**Subject: Palo Verde Nuclear Generating Station (PVNGS)  
Units 1, 2, and 3  
Docket Nos. 50-528/529/530  
Response to Request for Additional Information  
Concerning Floor Response Spectra For Seismic Qualification  
of Batteries at PVNGS - TAC No. M86200  
File: 94-010-026**

**REQUEST FOR ADDITIONAL INFORMATION  
CONCERNING FLOOR RESPONSE SPECTRA FOR  
SEISMIC QUALIFICATION OF BATTERIES AT  
PALO VERDE NUCLEAR GENERATING STATION**

**Floor Response Spectra for Seismic Qualification of AT&T Round Cell Batteries at  
Palo Verde Nuclear Generating Station (PVNGS)  
TAC No. M86200**

FIG. II(a)

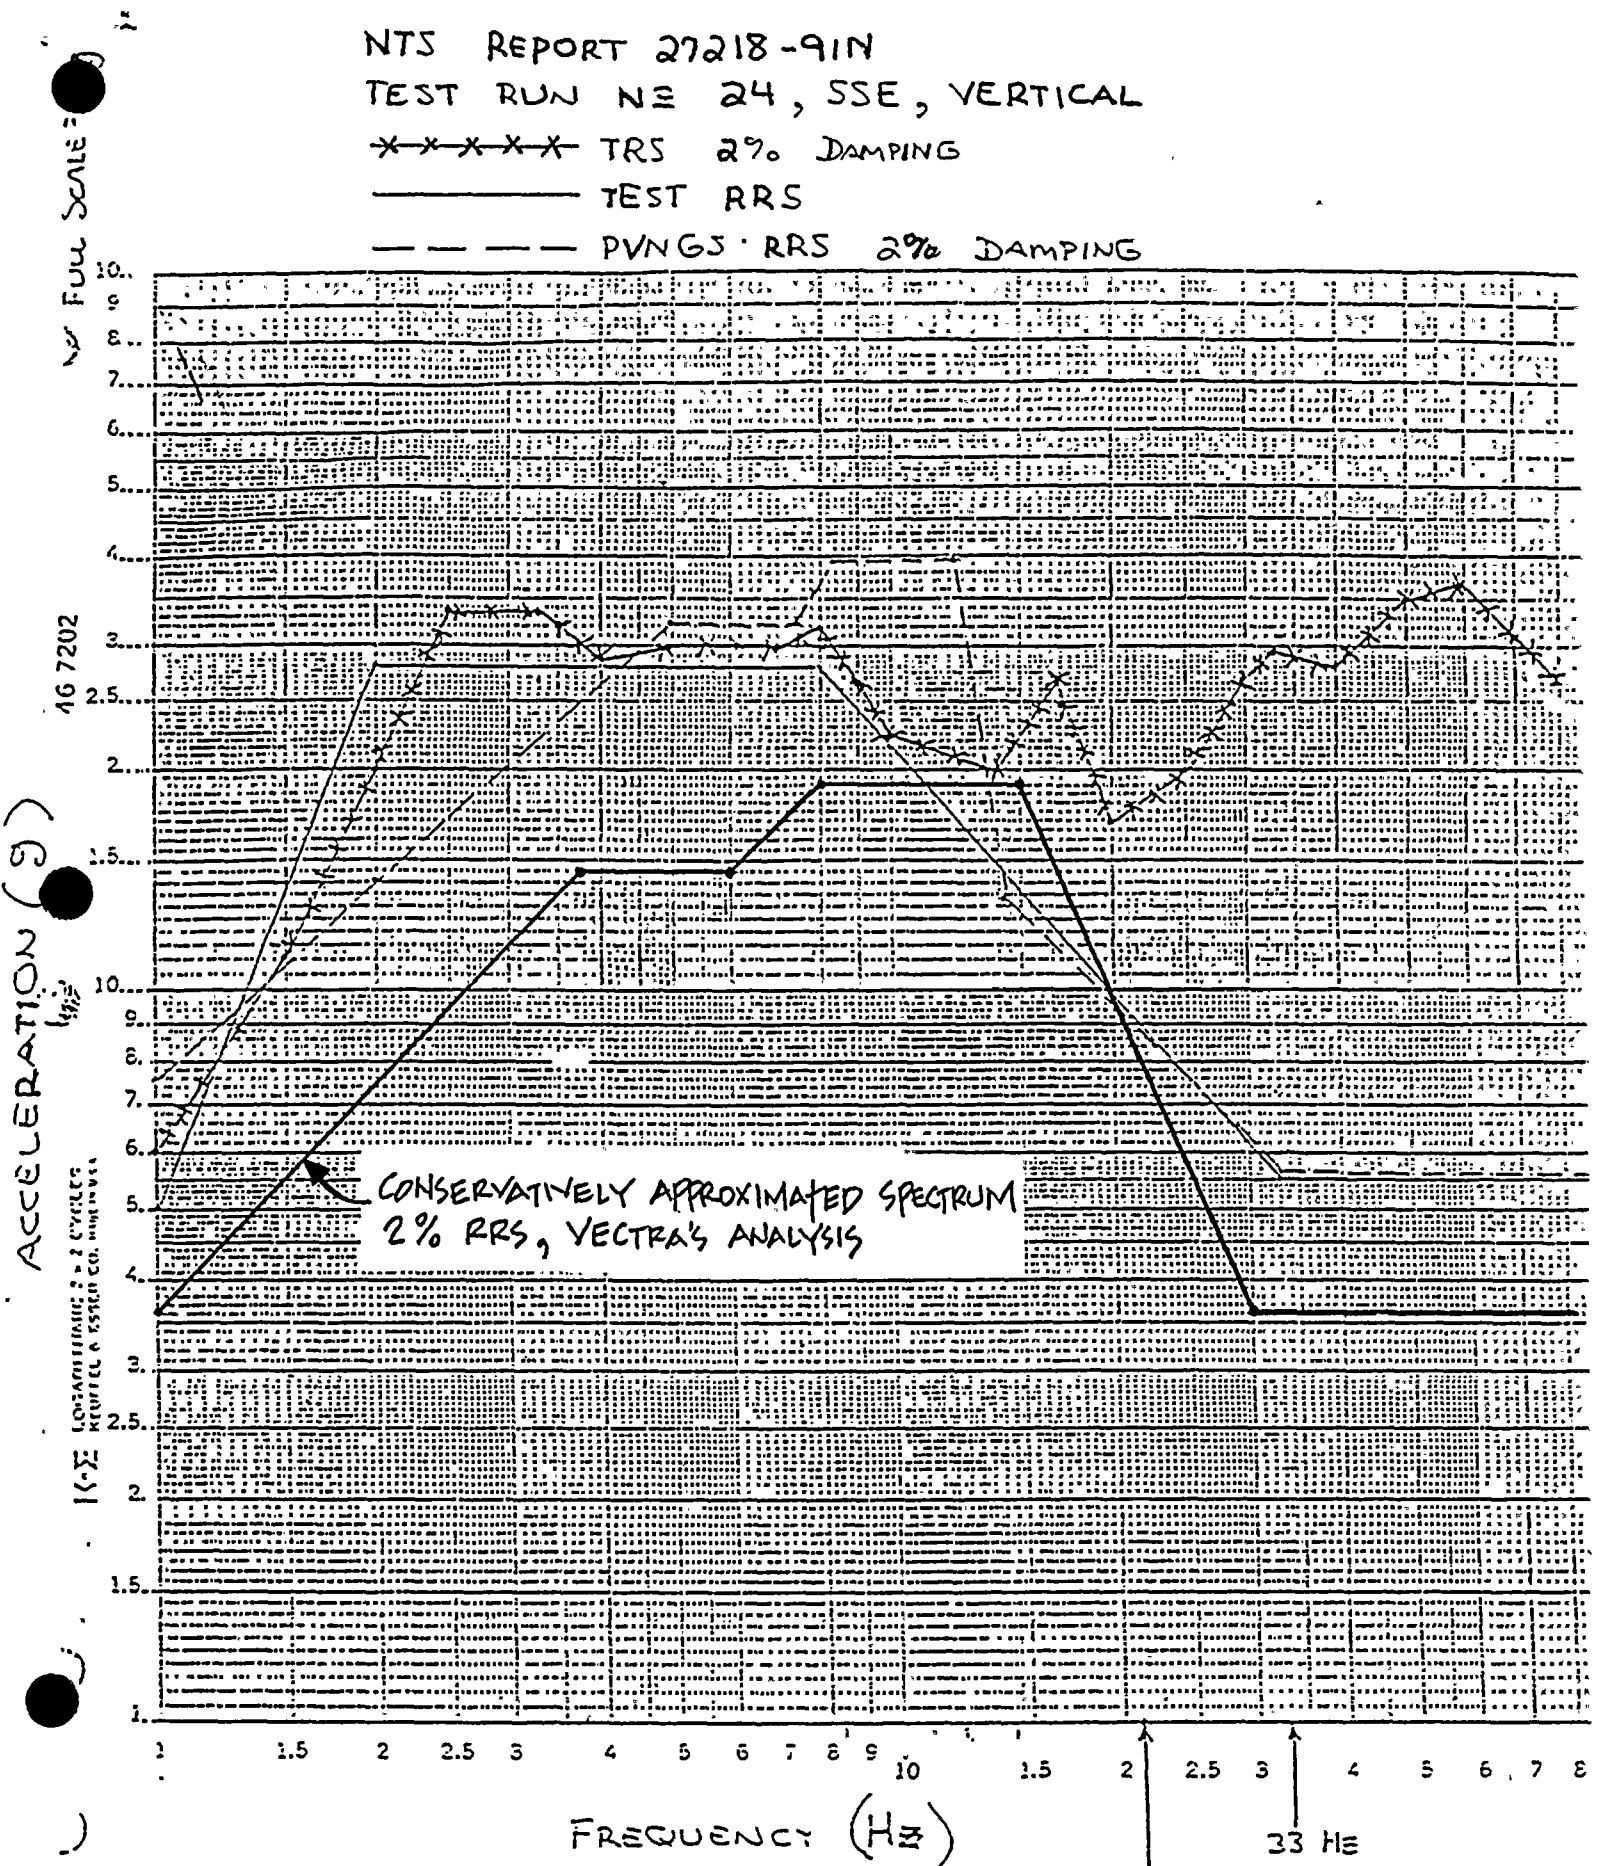
Vertical floor response spectrum (2% damping) at the batteries' locations of the structure which can be utilized for comparison with the TRS in Figure IIa (Reference 7).

A review of VECTRA's analysis of the Control Building reveals that PVNGS design basis response spectra for elevation 100' are very conservative. VECTRA's analysis also reveals that vertical SSE (increased by 20% for a PGA of 0.25g) and RLE response spectra for elevation 100' of the Control Building, at the batteries' locations, are enveloped by the vertical Test Response Spectrum (TRS) for the batteries. This is shown in Attachment B.

**Response to Request 4:**

Vertical floor response spectra (2% damping) at the batteries' locations from analysis that was performed by VECTRA are provided in Attachment E. Vertical floor response spectrum (2% damping) at the batteries' locations was not generated in Bechtel's Study No. 13-CS-102.

**Vertical Synthetic Time History**

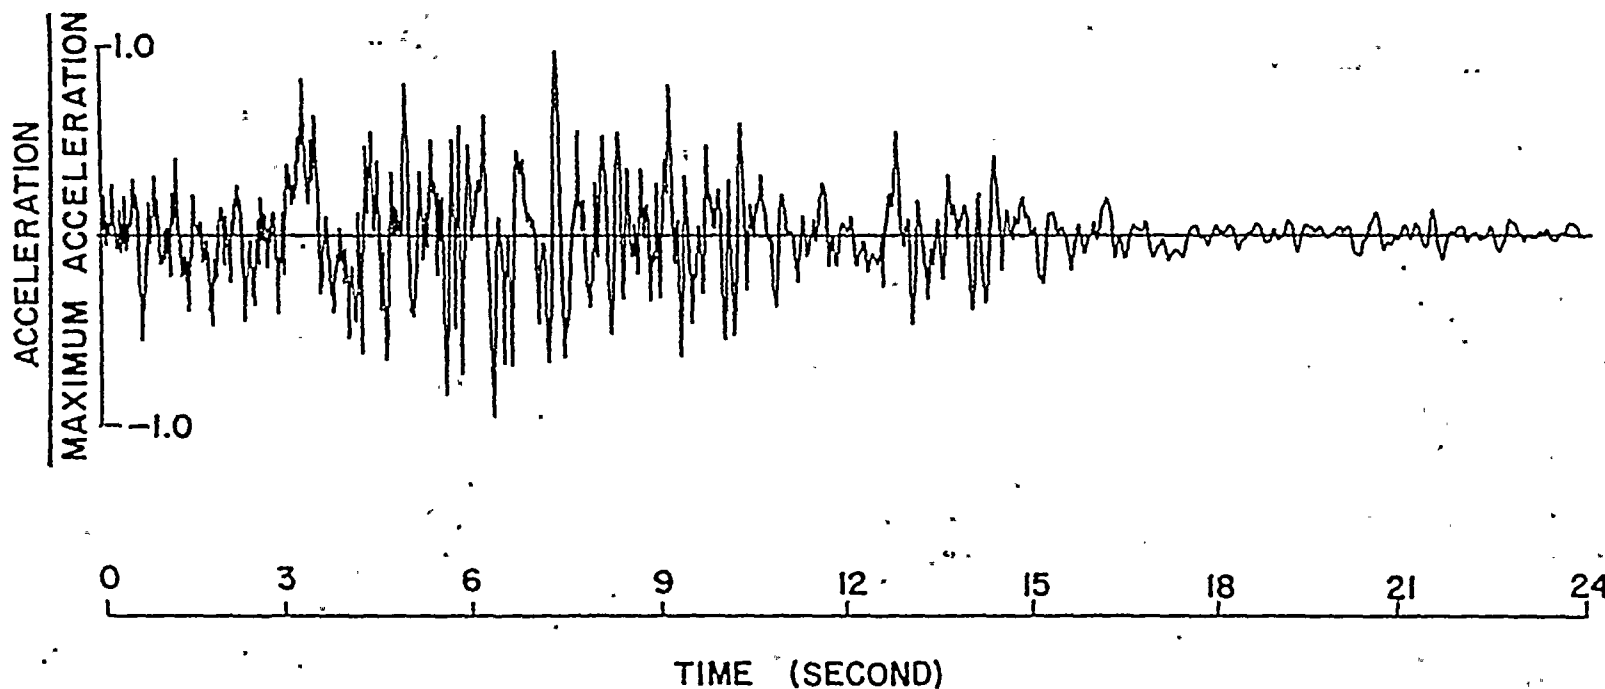
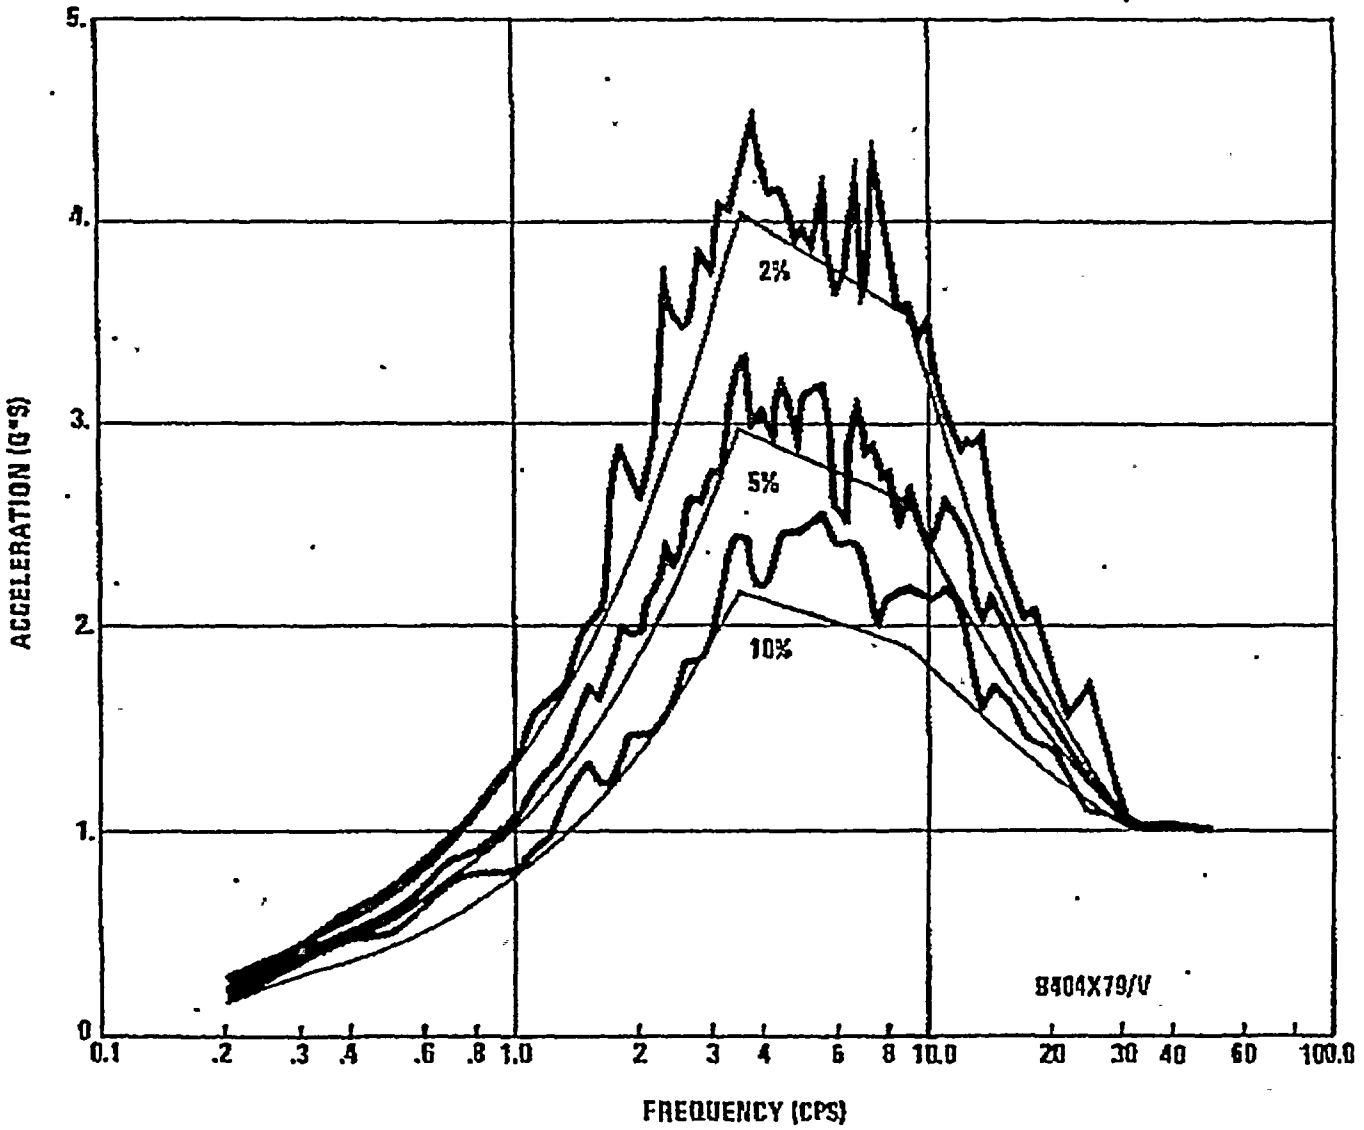
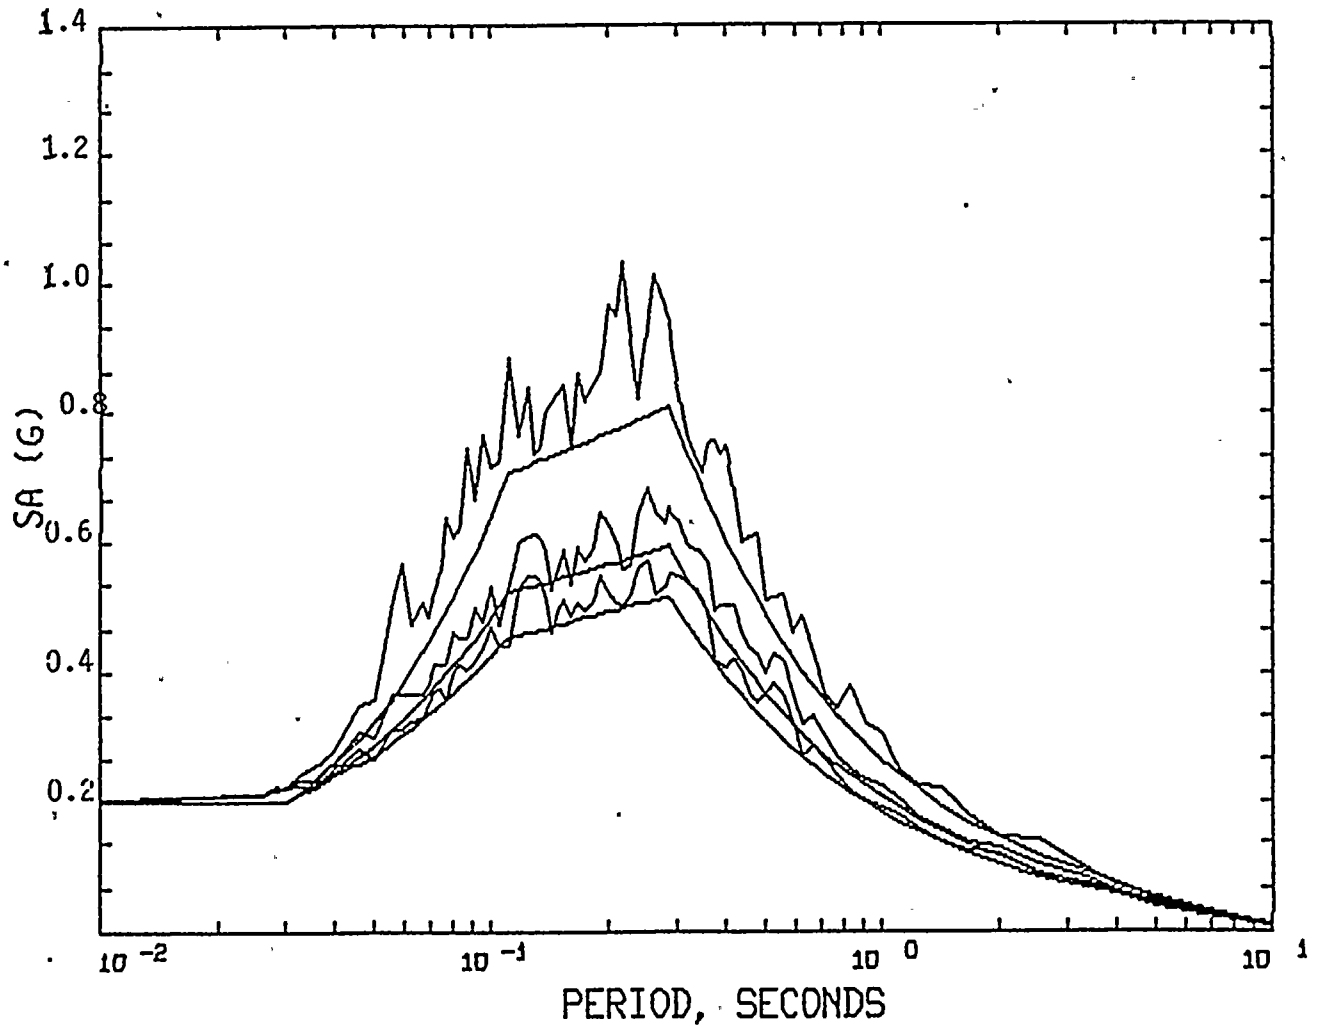
Synthetic time-history (vertical) at the grade level.

Synthetic time-histories (vertical) at the grade level from analyses that were performed by Bechtel and VECTRA are provided in Attachment C.

**Vertical Response Spectra at the Foundation Level and 60% of the Design Ground  
Response Spectrum**

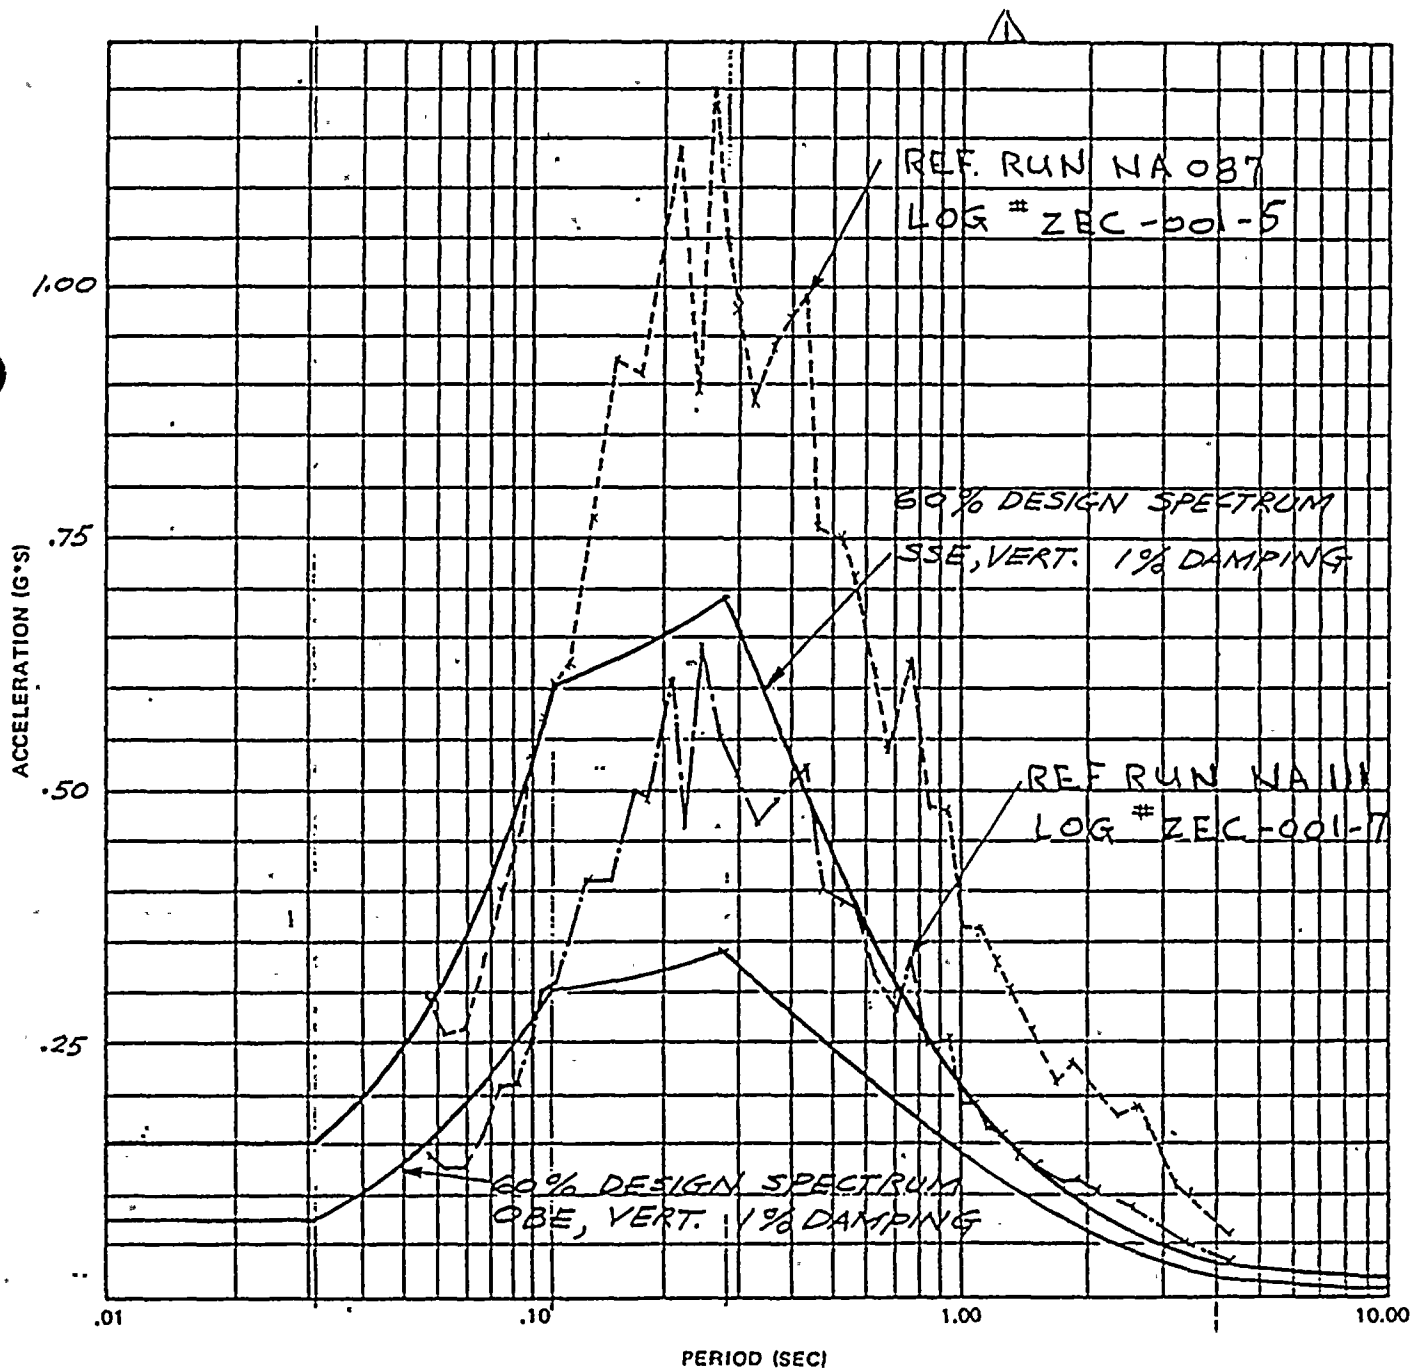
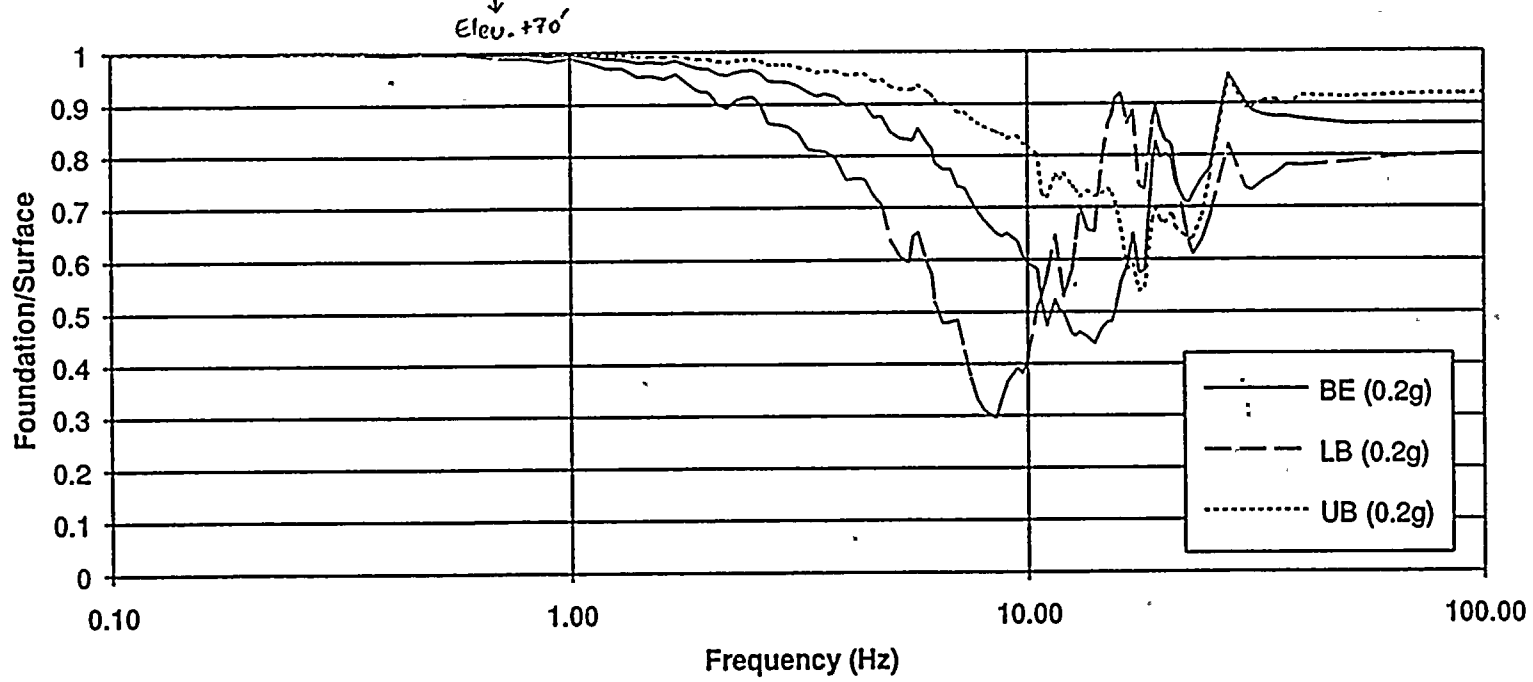
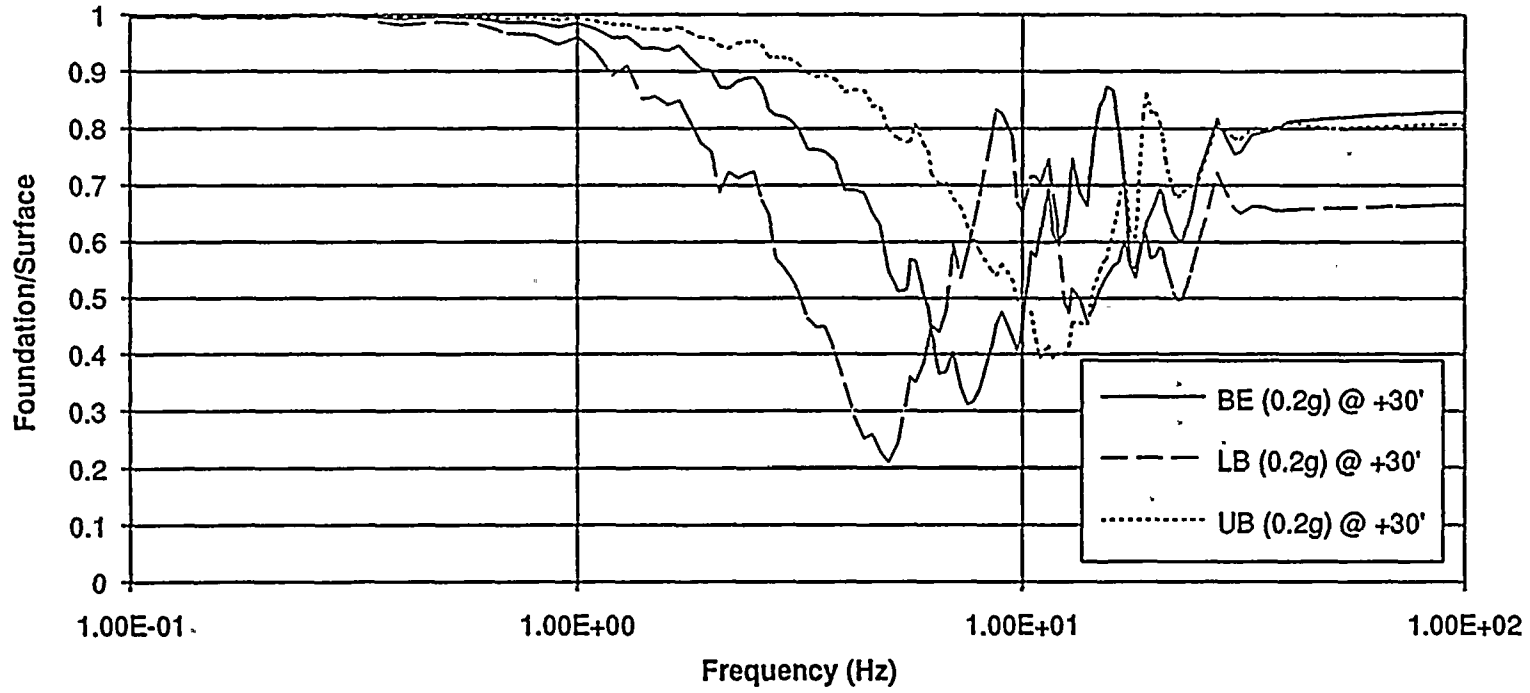
Vertical response spectra at the foundation level and 60% of the design ground response spectrum.

The vertical response spectra at the foundation level and 60% of the design ground response spectrum from analyses that were performed by Bechtel and VECTRA are provided in Attachment D.
